Addendum No. 1

Project: Washoe Park Trout Hatchery Isolation Building Facility Project

FWP Project #: 7153604 Date: May 24, 2016

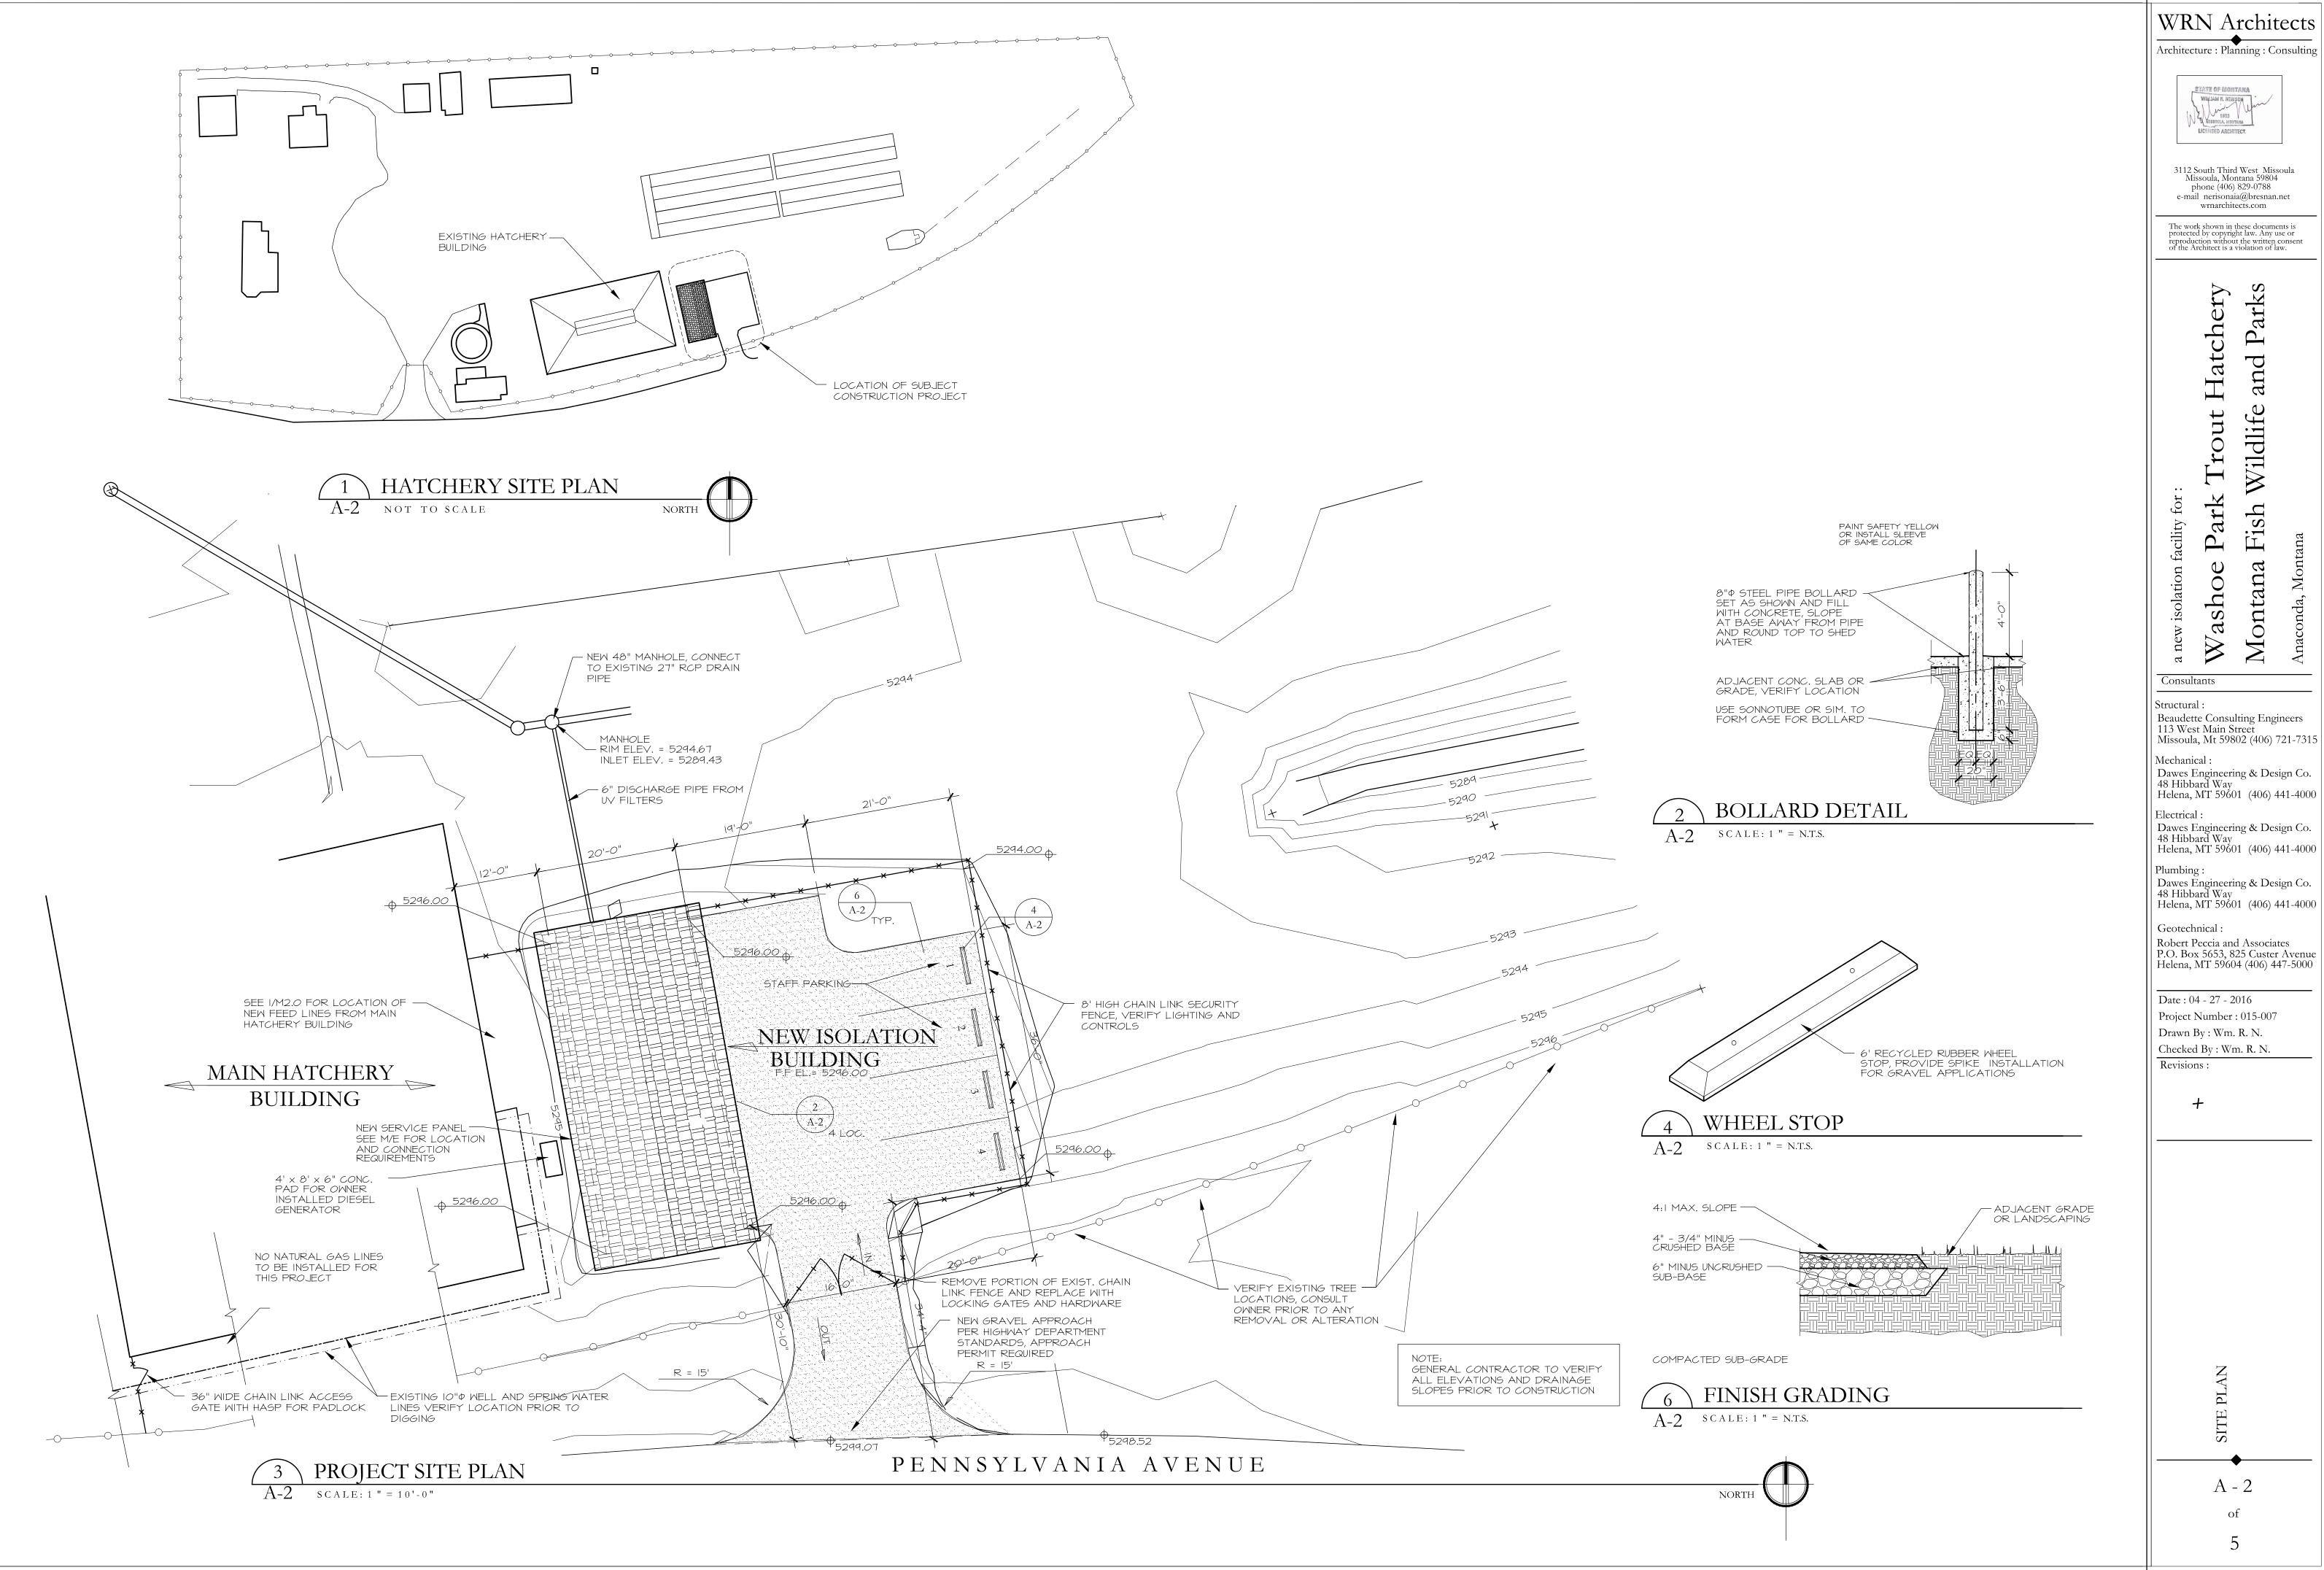
- 1. Dimensions have been added to the parking lot and approach on sheet A-2.
- 2. Rim elevations have been added on sheet A-2.
- 3. Window width is 5'-0" not 6'-0" and has been changed on sheet A-3

- 6. A pad for a owner installed generator has been added to the site plan on sheet A-2
- 7. Fiberglass, pultruded FRP, solid decking or metal grating that is hinged on the side opposite the access ladder and is rated for 100lbs per s.f. is acceptable for covering of the UV pit. No locking mechanism is required. Product information shall be submitted to architect for approval

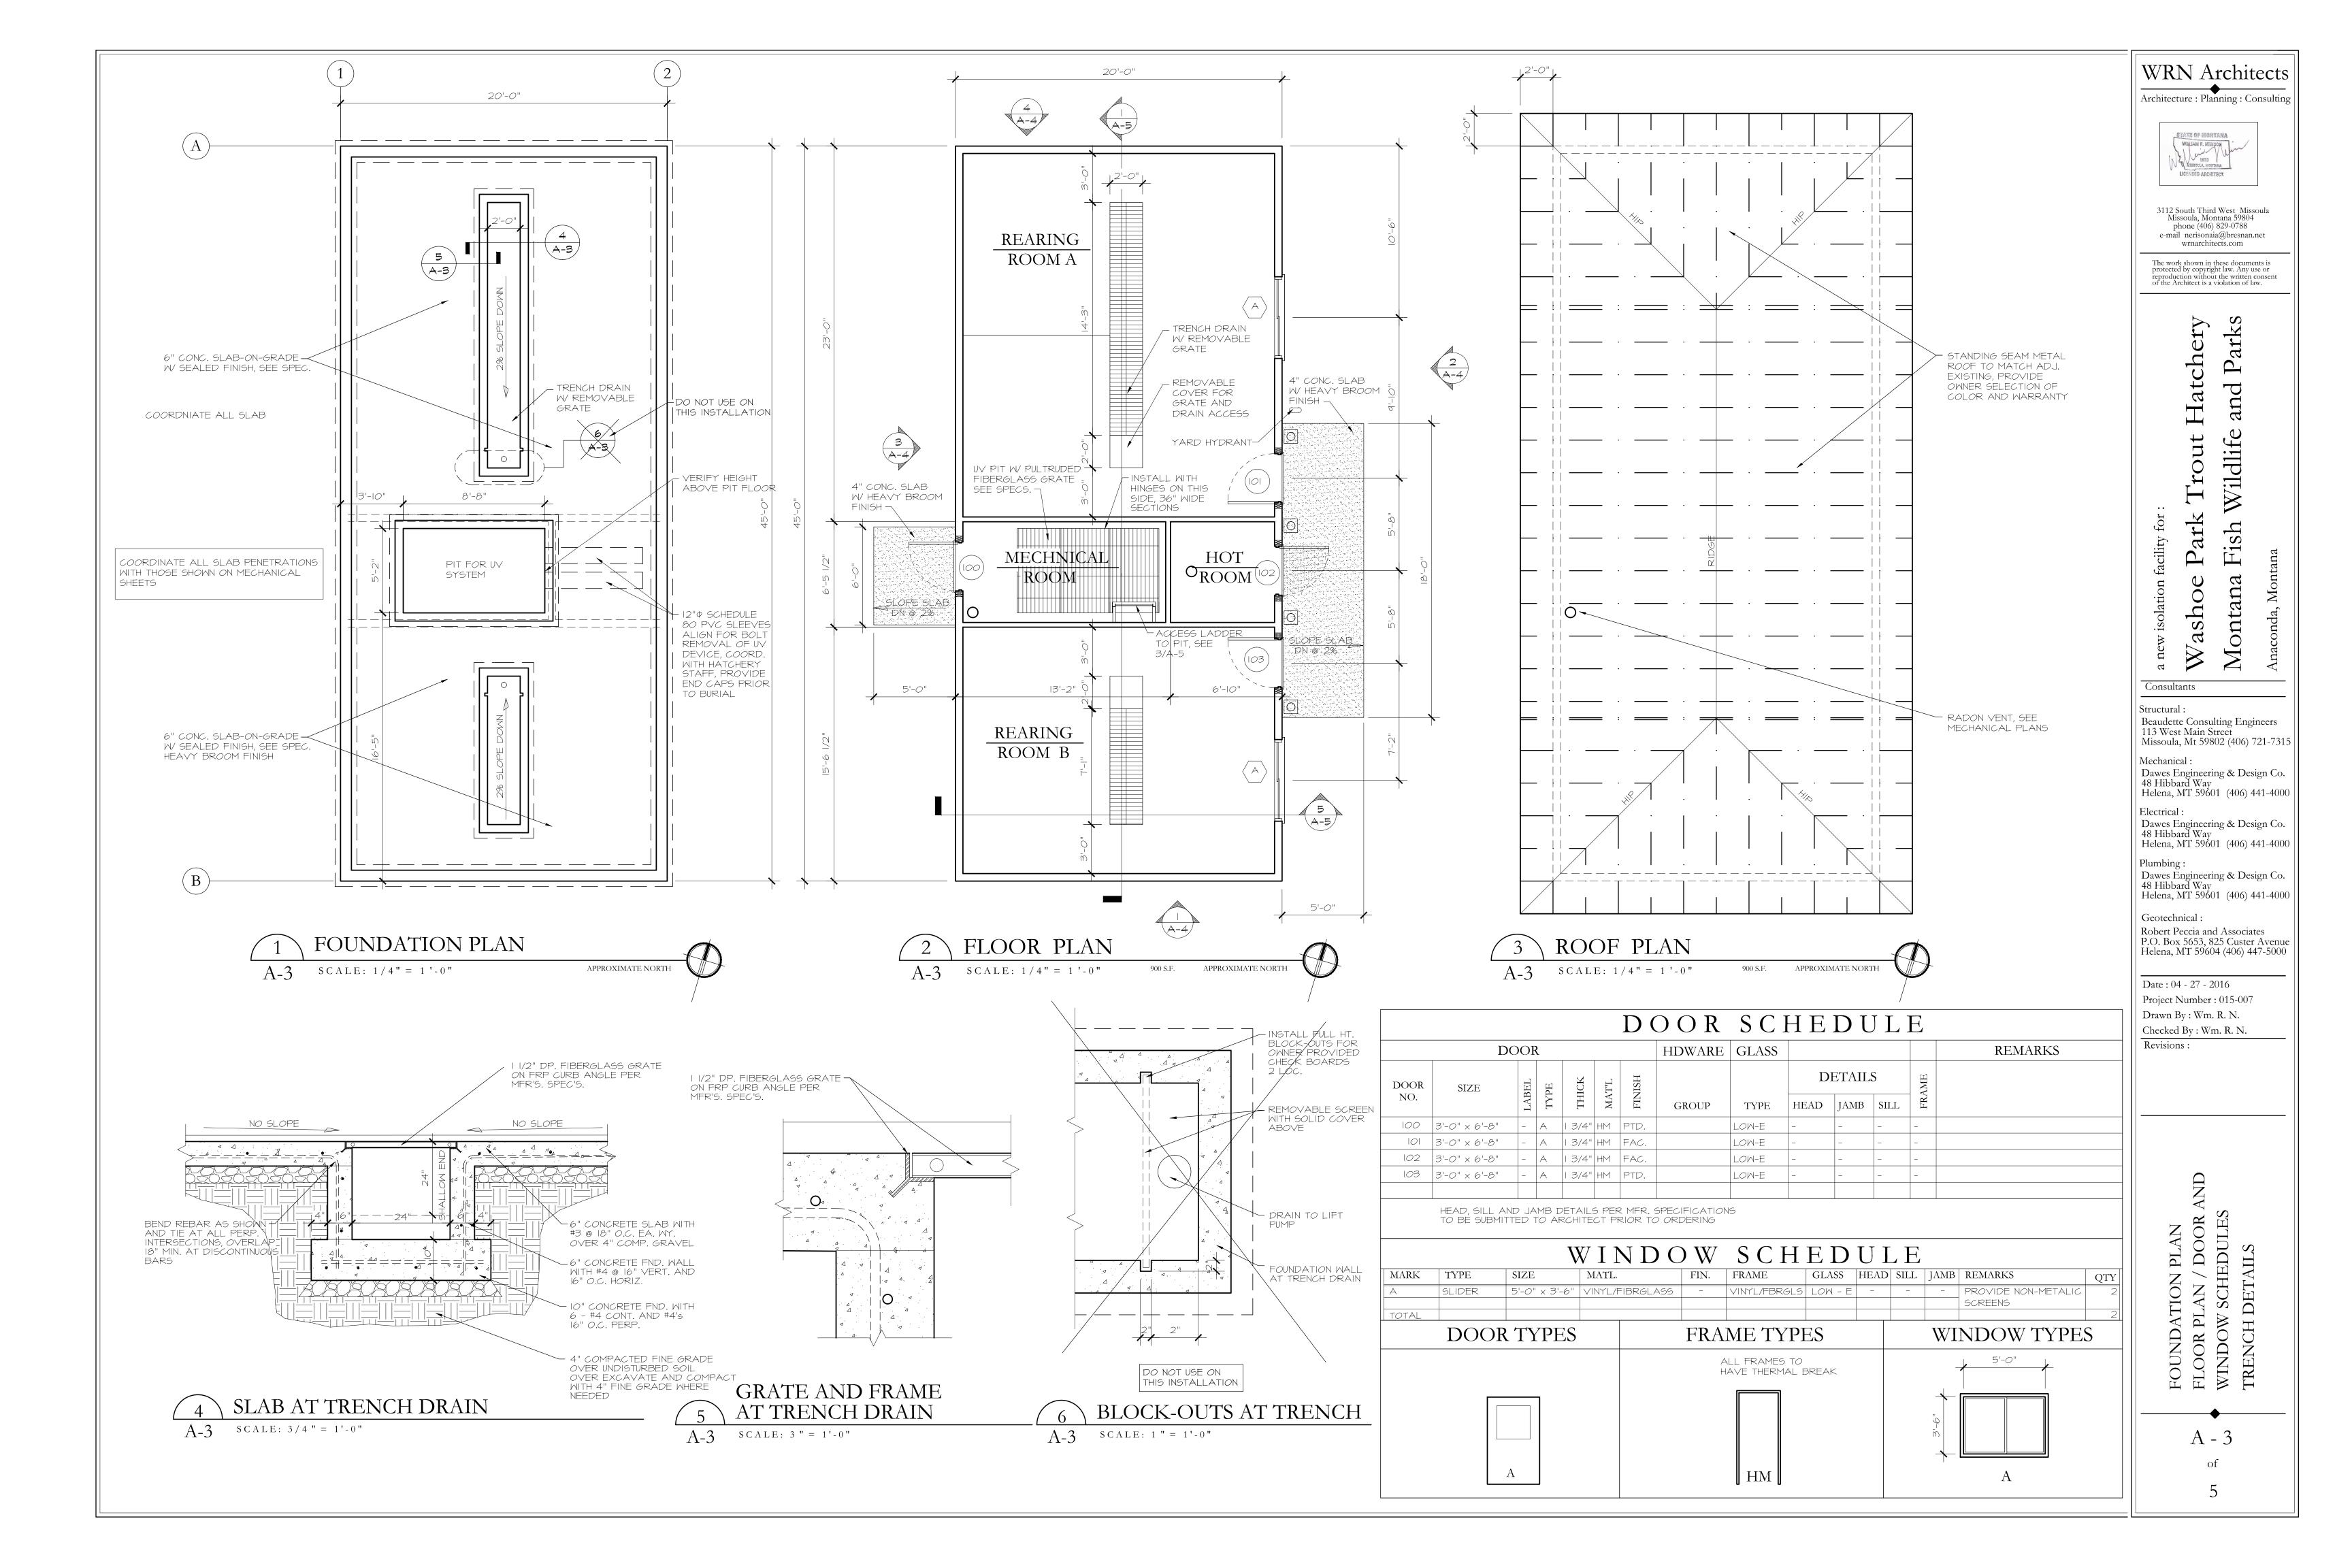
- 4. The pit ladder placement has been changed on sheet A-3 to reflect correct orientation.
- 5. Emergency lighting is not required by code in this building.
